**ORDNANCE AND EXPLOSIVES
ENGINEERING EVALUATION/
COST ANALYSIS REPORT – RESPONSE TO
COMMENTS**

**SENECA ARMY DEPOT
ROMULUS, SENECA COUNTY, NEW YORK**

**SENECA ARMY DEPOT ACTIVITY
and
U.S. ARMY CORPS OF ENGINEERS
NEW YORK DISTRICT
and
HUNTSVILLE CENTER**

Figure 3.10A
Location of EM-31 Survey
Indian Creek Burial Area

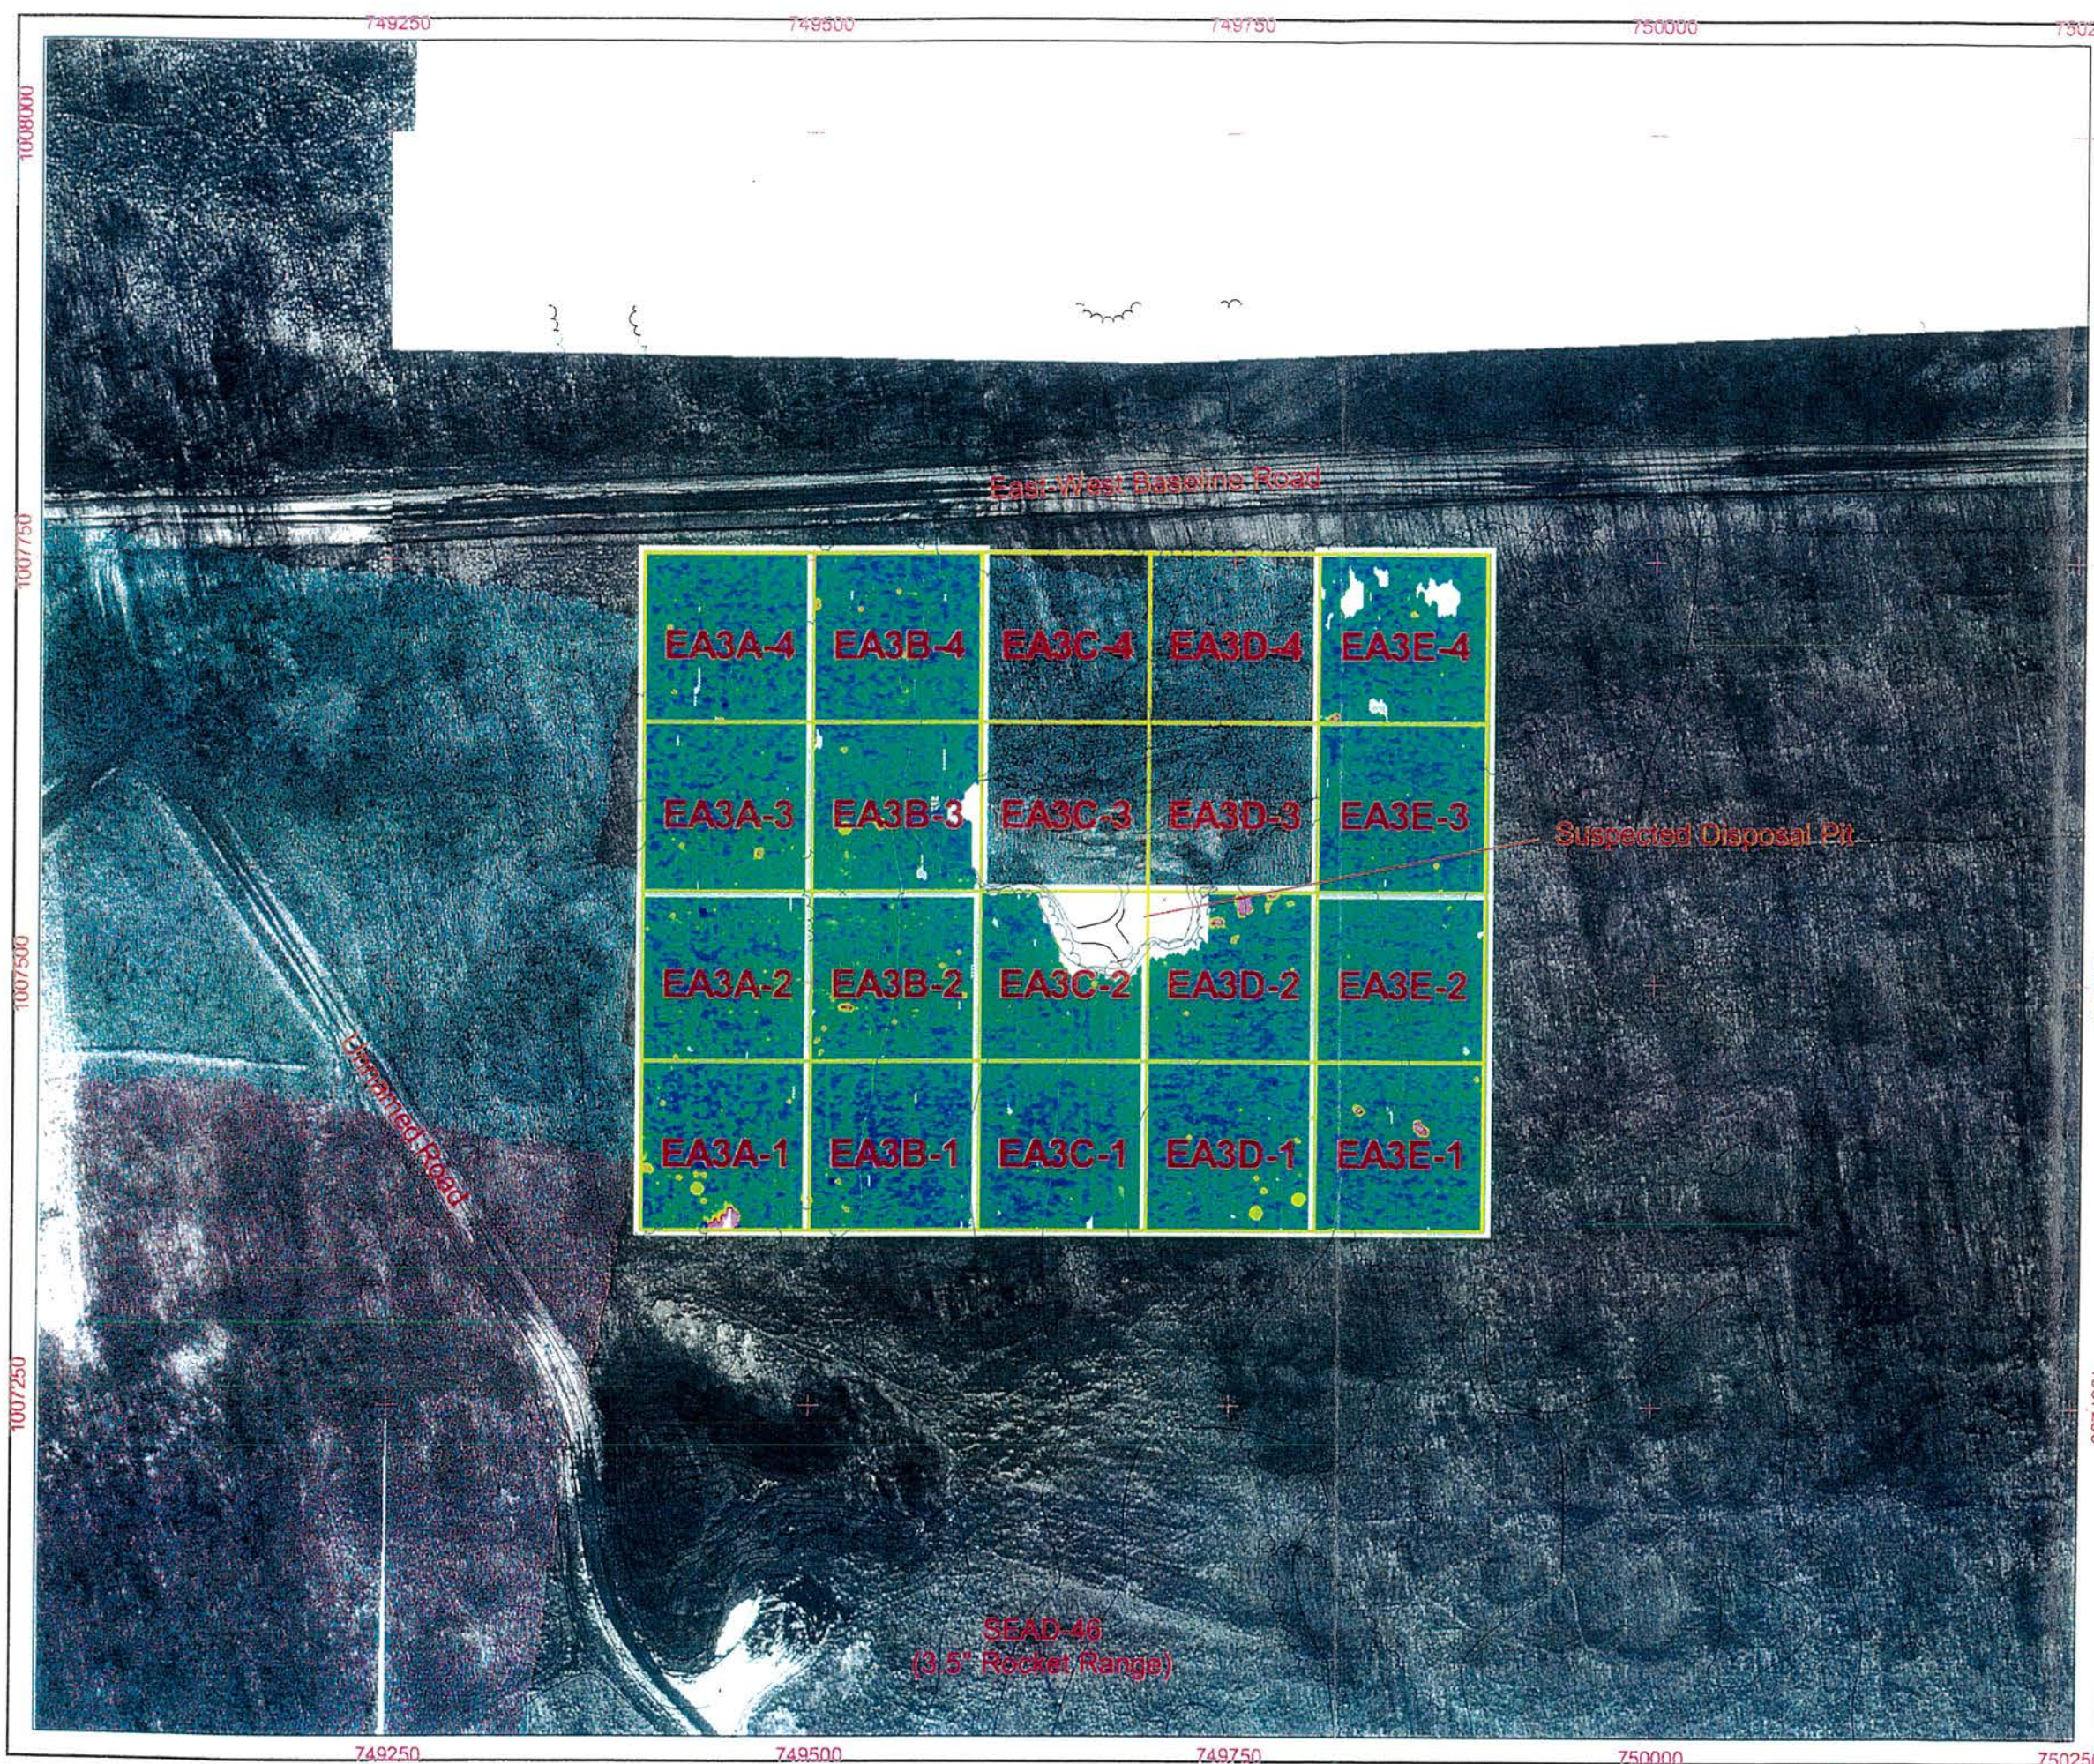
15. **Figure 3.10.** This figure provides the area investigated in the Indian Creek Burial Area. The figure does not provide an overlay of site features as on the other figures. Site features should be overlain so that the area of investigation can be clearly identified.

Response to EPA: No topographic overlay exists for this area. However, another figure (Figure 3.10A) has been added to the report. This figure, included in Appendix A of this document, shows the aerial photo with nothing overlaying it other than the outline of the area covered by a 1999 EM-31 survey. It is this survey that gives the justification for moving the survey area away from the Indian Creek road. Section 2.7.8 has also been added to the Previous Investigations section of the report. This new section gives a brief description of the EM-31 survey performed at the Indian Creek site.

EM-61 Response
(mV)

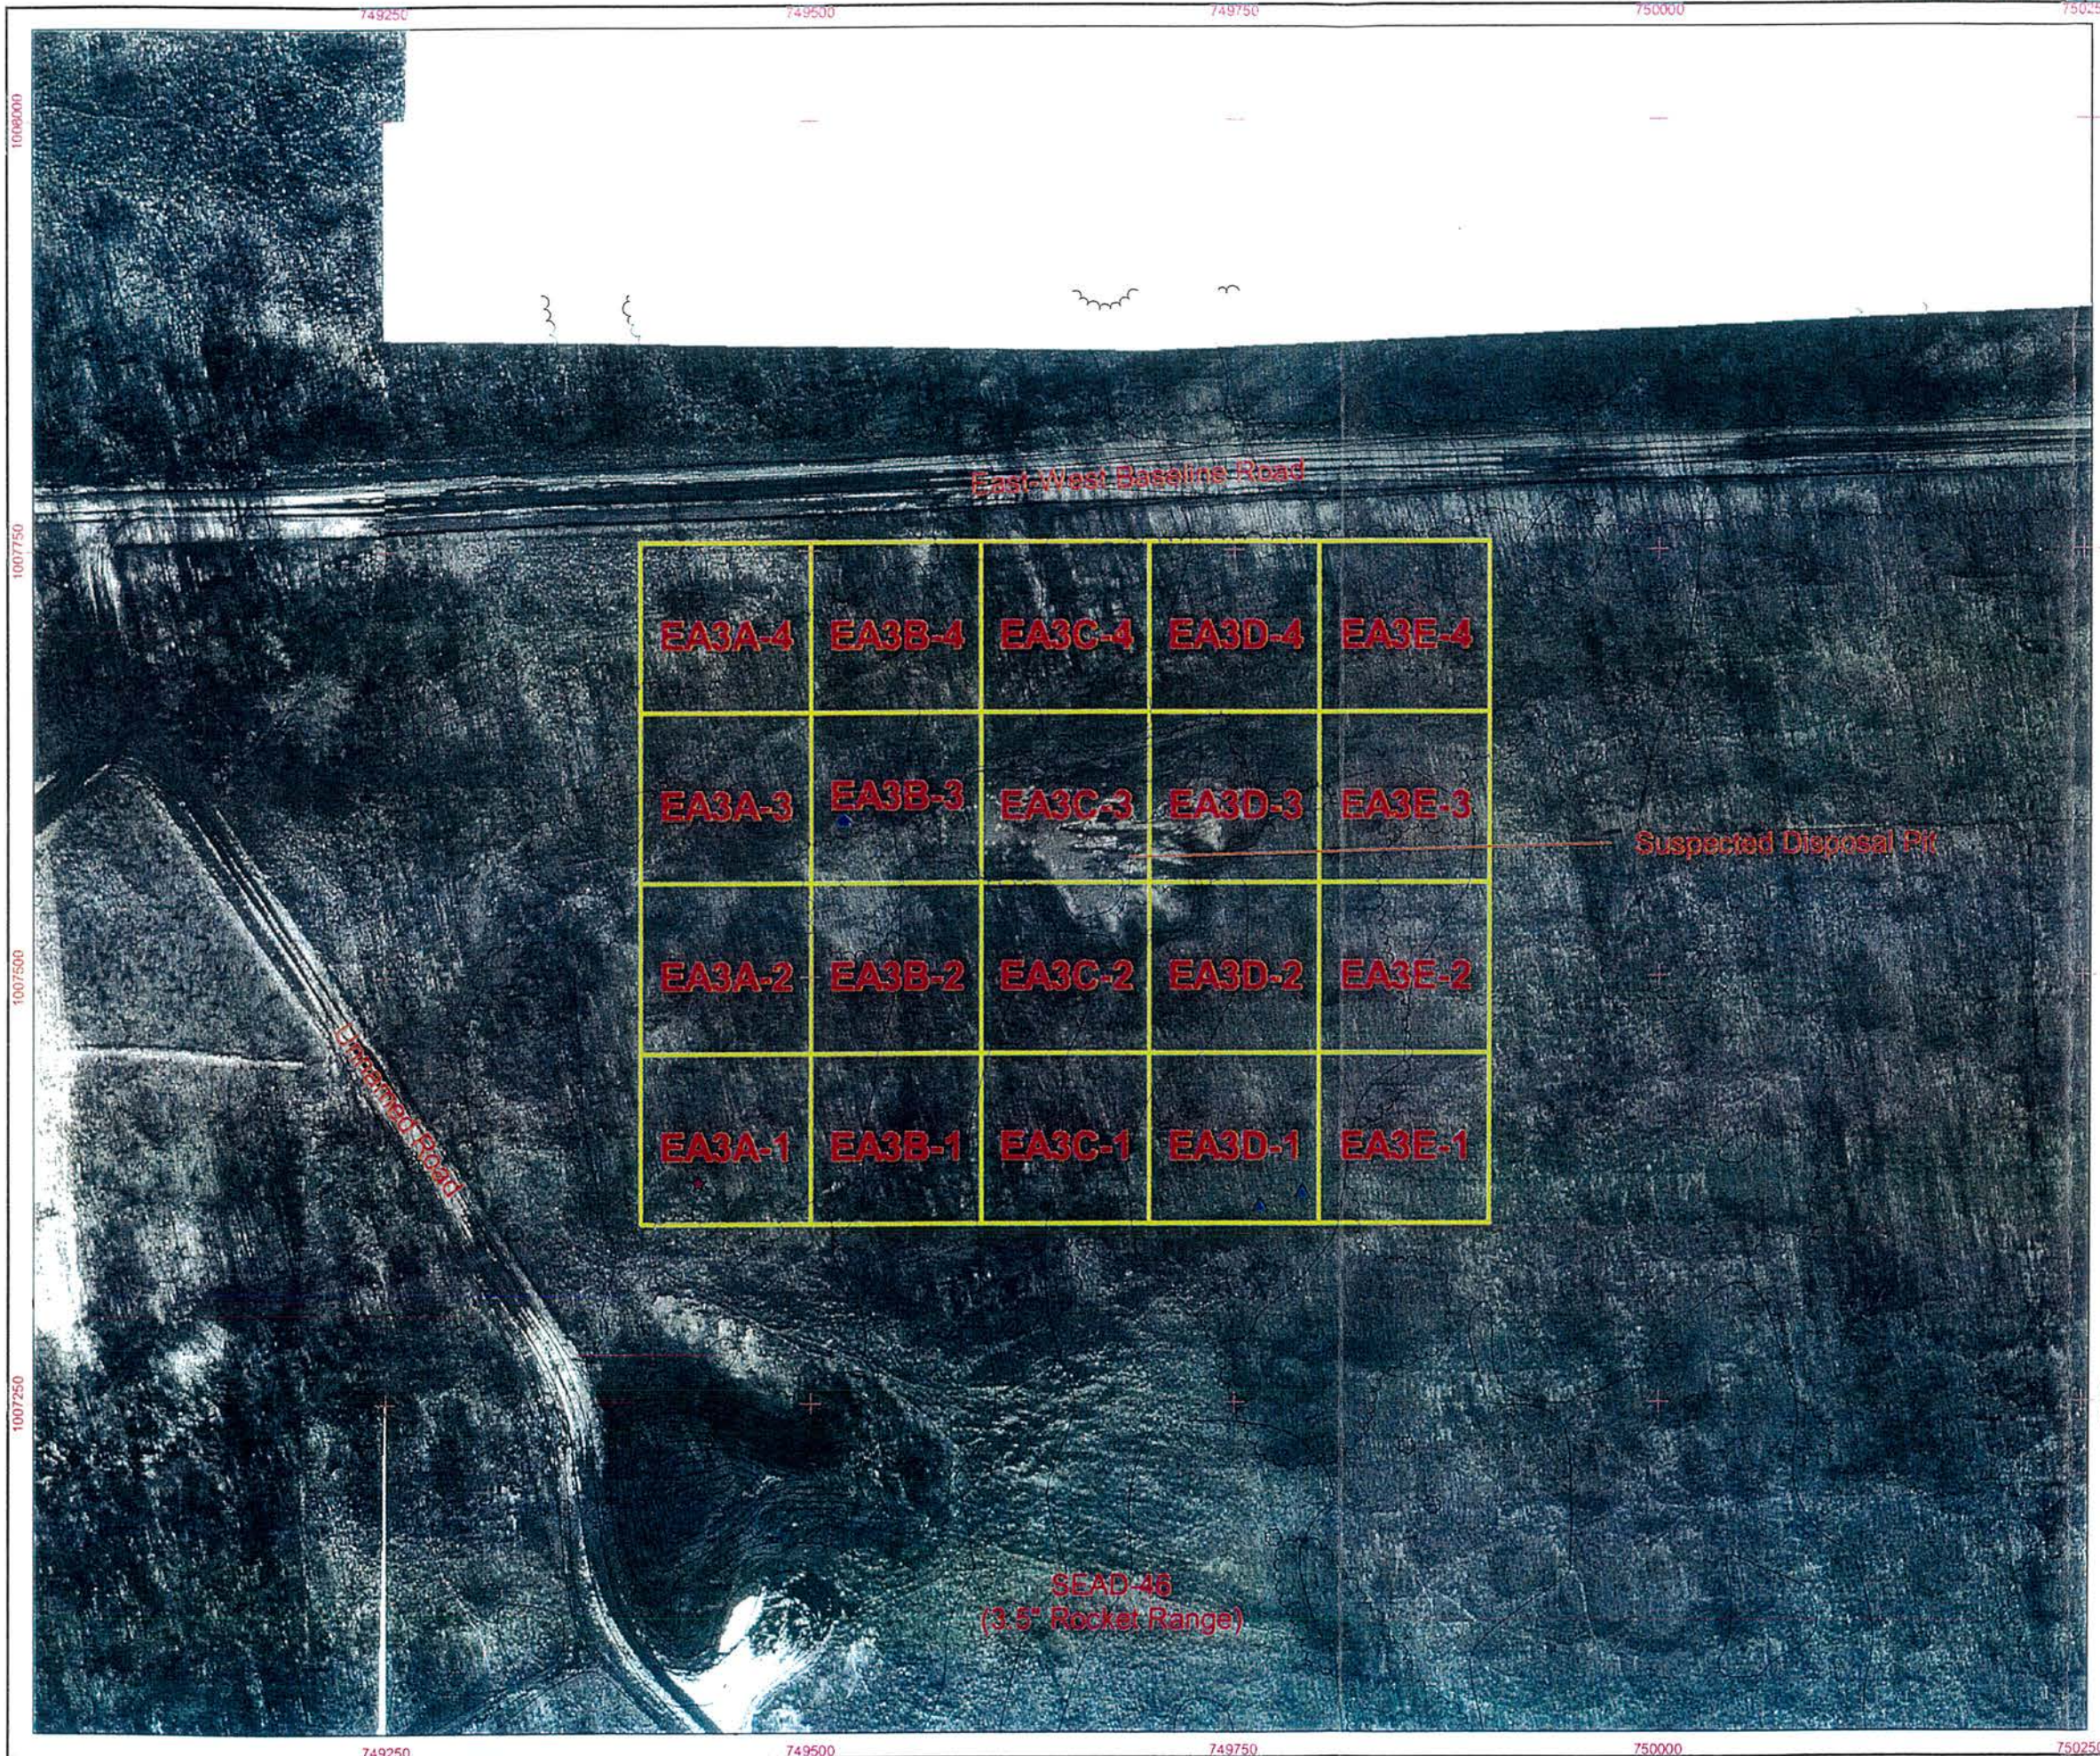
10. **Section 3.8.6, page 3-13.** This section provides information on the investigation conducted at EOD Area #3. Text on page 2-5 indicates that an ordnance disposal pit and ditch were present at the site. The pit is visible on Figure 3.15, and was not geophysically investigated, adding to the uncertainty associated with the response action. Efforts to investigate the pit and ditch at this site should be discussed in the text. In addition, these features should be labeled on Figures 3.15 and 3.16. These areas should be investigated if they can be located.

Response to EPA: There is only one feature in this area, which had been referred to as both a pit and a ditch in Section 2. Section 2.2.2.2.9 has been revised to refer to the area in question as a pit in all instances.

Section 3.8.6 has been amended to say that the pit was located in the area that could not be surveyed due to thick woods/brush. In part because of this, the proposed response action at EOD #3 is a clearance to depth. Included in the estimated cost for this response action (page G-3) is the heavy brush cutting necessary to investigate the remainder of this AOI. The only more extensive response action would be a scrape and sift. It is highly unlikely that such a process would be necessary in this area judging by the scarcity of OE surrounding the suspected pit.

3.8.6.1 Sixteen 100-foot by 100-foot grids were surveyed in EOD Area #3 using the EM-61 (Figure 3.15). This acreage represents 80% of the 5-acre AOI. Four grids in this area, including the actual location of the suspected disposal pit, were not surveyed due to thick woods that could not be cleared using the brush cutting tools available.
